COVER DOCUMENT

System Pillar / EULYNX

Baseline Set 4 Release 3

Error corrections

[EUP-576] Wrong transition condition in STM diagram**F Control And Observe 4W PM**

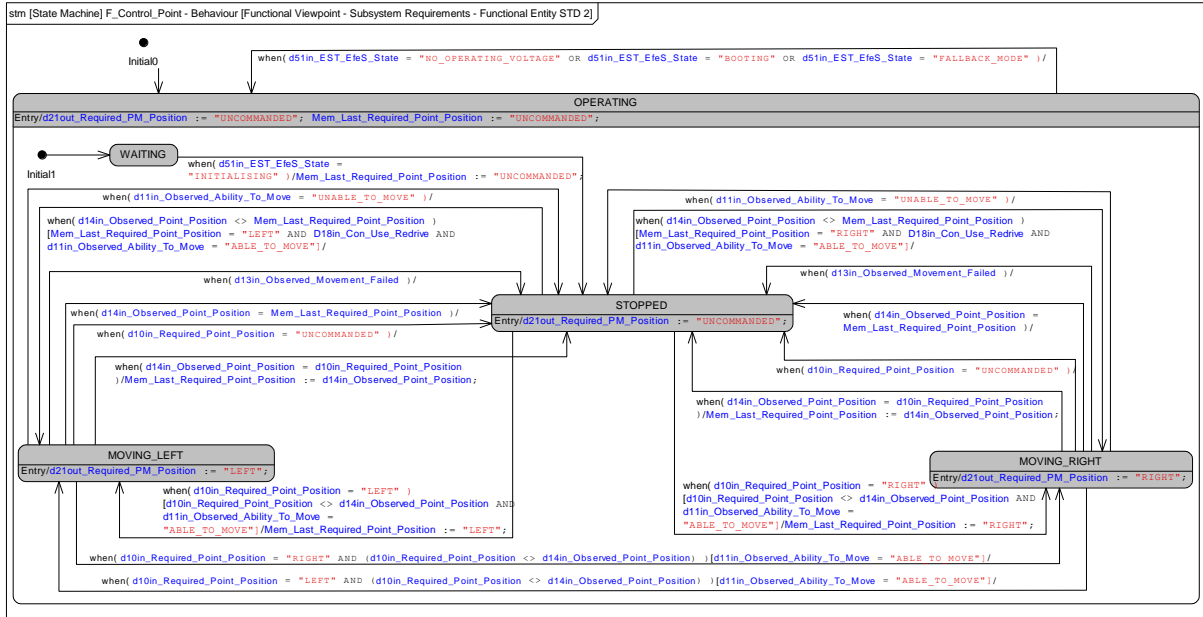
The STM diagram F_Control_And_Observe_4W_PM (Eu.P.5823) contains an error. The 2nd transitions from MOVING_LEFT_PM / MOVING_RIGHT_PM to DETECTION contain `d12in_Required_PM_Position = "LEFT_REACHED" / d12in_Required_PM_Position = "RIGHT_REACHED"`. This condition can never be true, because the values "LEFT_REACHED" / "RIGHT_REACHED" are not used for the port `d12in_Required_PM_Position`.

The correct transition must be `d27in_4W_PM_Position = "LEFT_REACHED" / d27in_4W_PM_Position = "RIGHT_REACHED"`.

The correct transitions are shown in the attached figure.

[EUIO-439] [SDI-IO, correction of multiplicities for PhysicalChannelConnection](#) Created: 26.07.2024 Updated: 26.07.2024

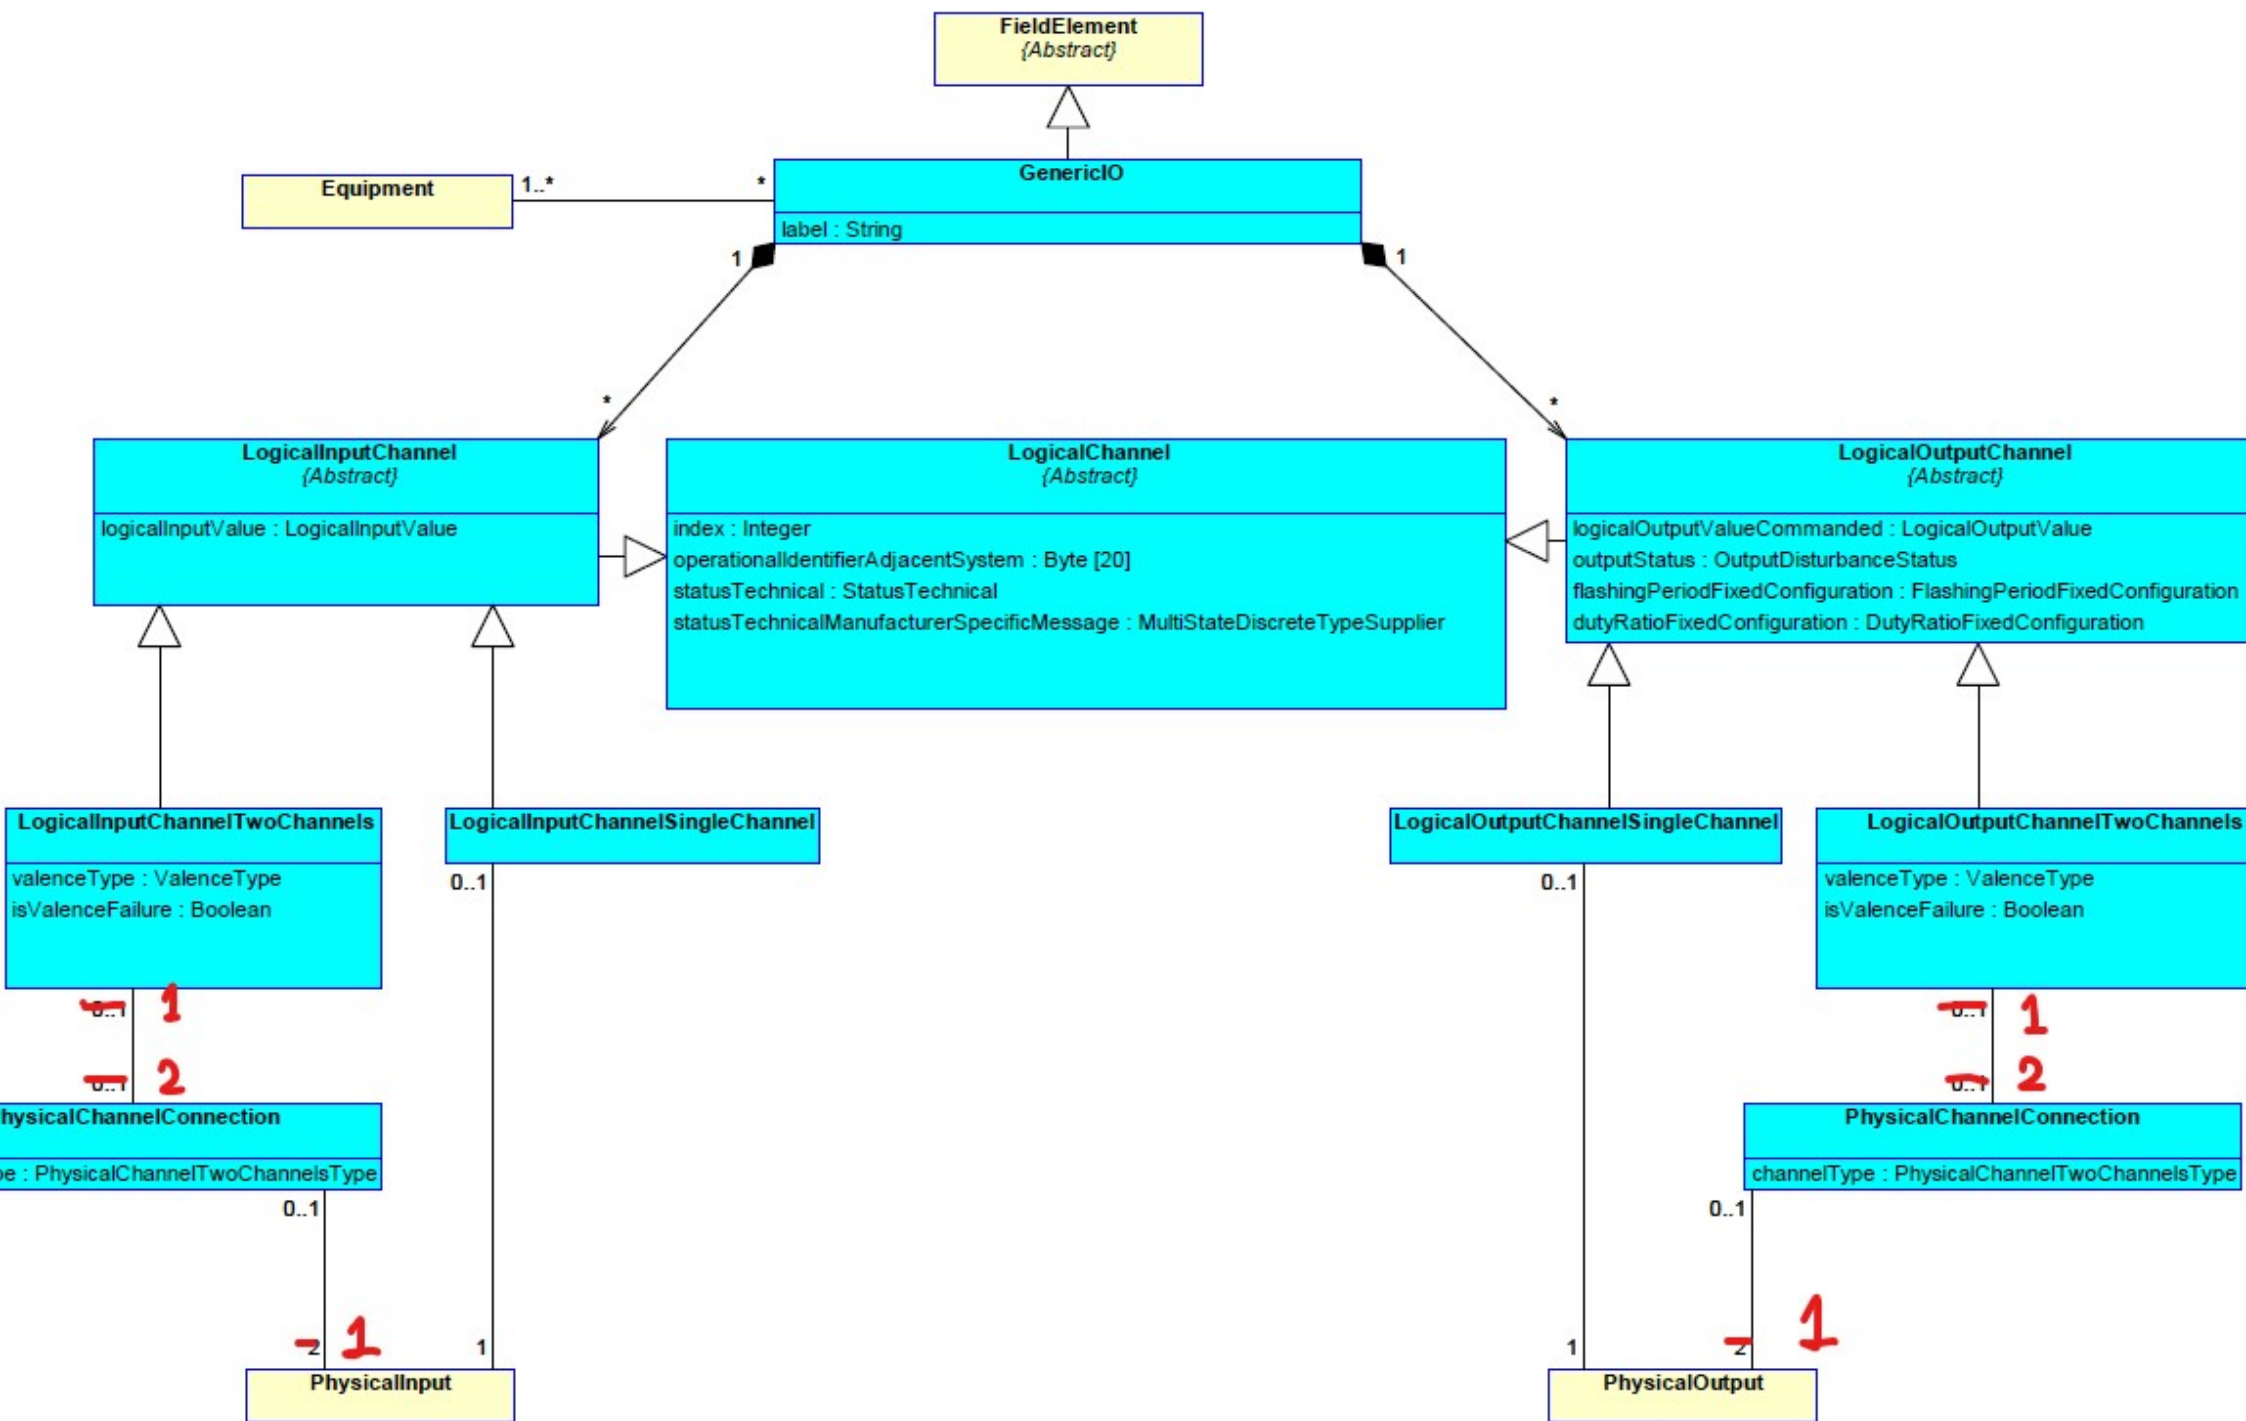
Problem
The multiplicities between LogicalInputChannelTwoChannels, PhysicalChannelConnection and PhysicalInput are incorrect.
Also valid for the multiplicities between LogicalOutputChannelTwoChannels, PhysicalChannelConnection and PhysicalOutput.

Intended state
See figure.

SPT2TACS-8740 - Correct missing Operation_State when leaving Data_Update

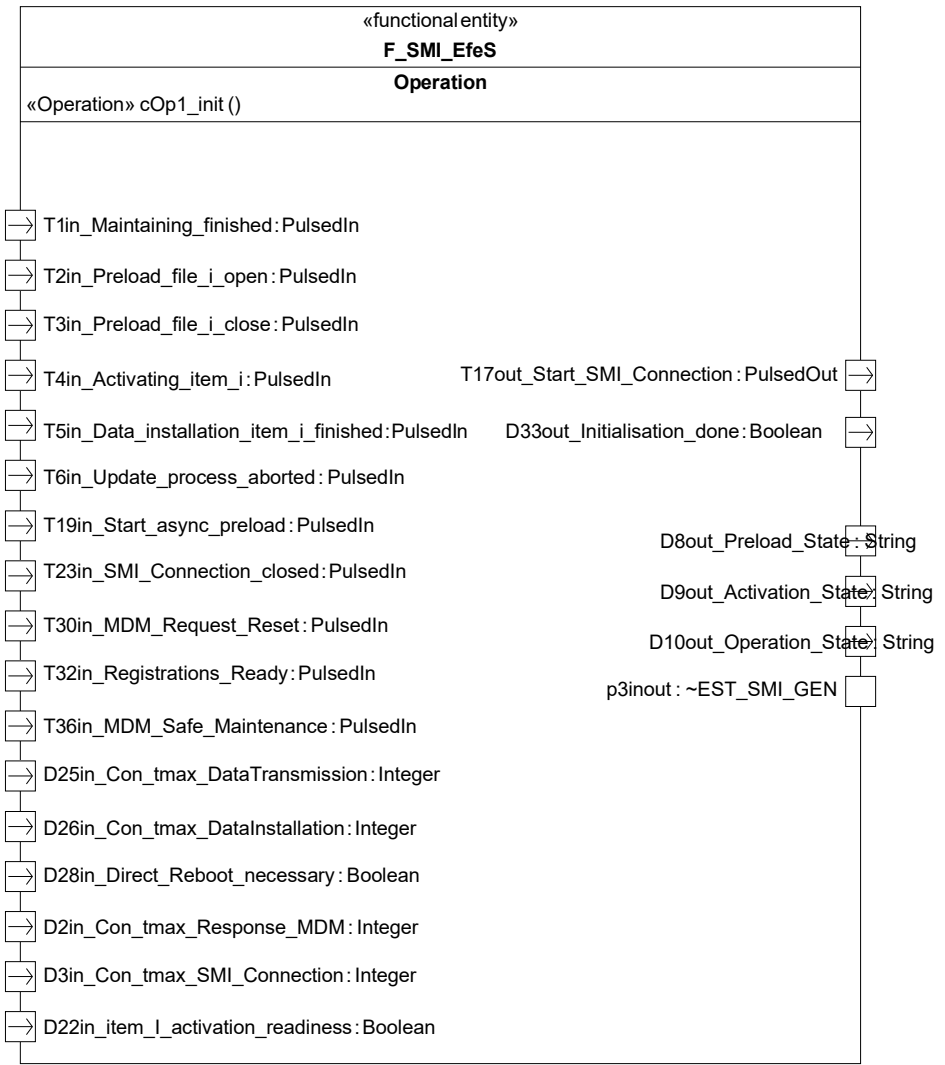
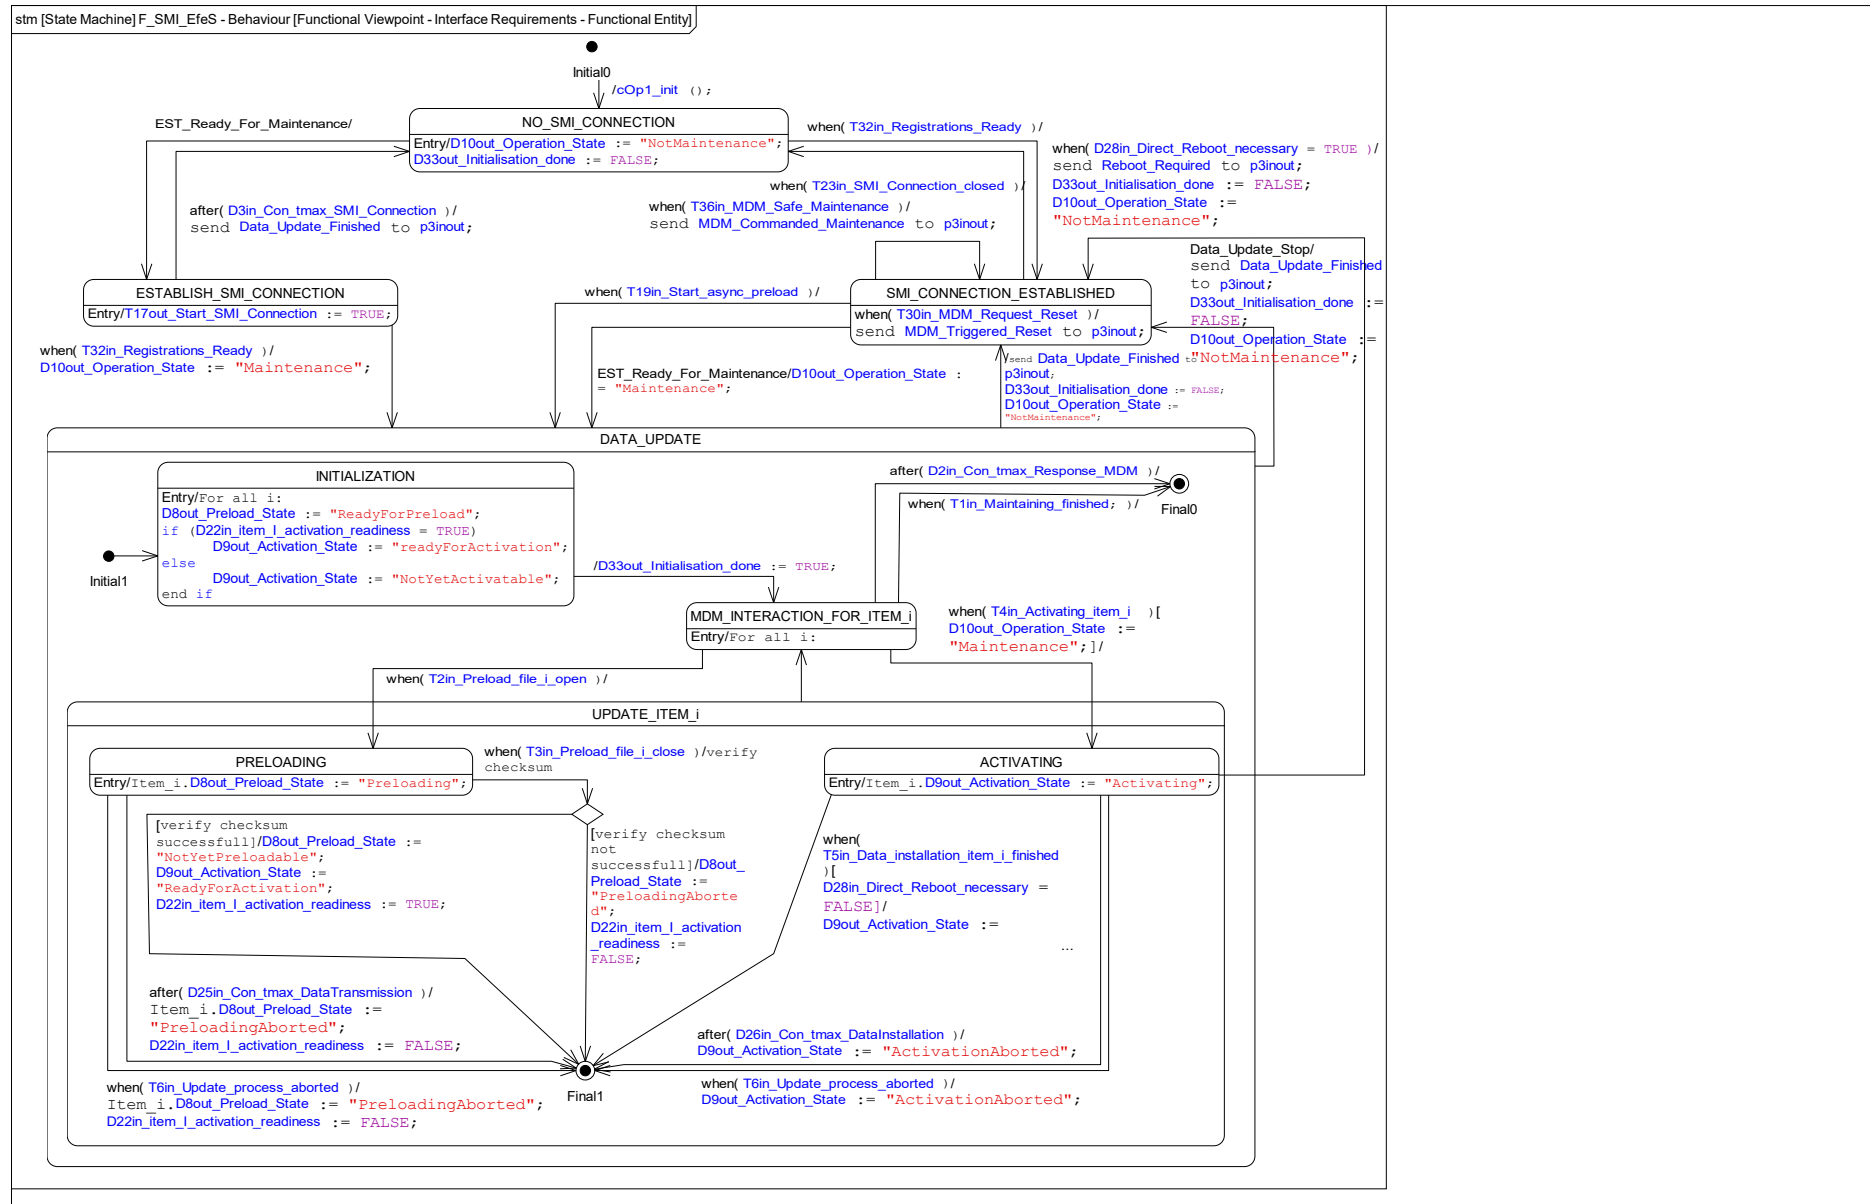
Problem Description: PILZ raised that the reaction D10out_Operation_State = "NotMaintenance" is missing at the transitions going out of Data_Update. This means that the value of D10out_Operation_State is not defined in the state SMI_CONNECTION_ESTABLISHED, it can be either "NotMaintenance" or "Maintenance". This unclarity is not intended, the value must be "NotMaintenance".

Proposed Solution: Add D10out_Operation_State = "NotMaintenance" in 3 transitions going out of the state DATA_UPDATE.

In the transition from MDM_INTERACTION_FOR_ITEM_I to ACTIVATING, delete the condition d52in_EST_EfeS_init_SubState = "WAITING_FOR_DATA_UPDATE" and replace it with D10out_Operation_State = "Maintenance". The port d52in is no longer needed.
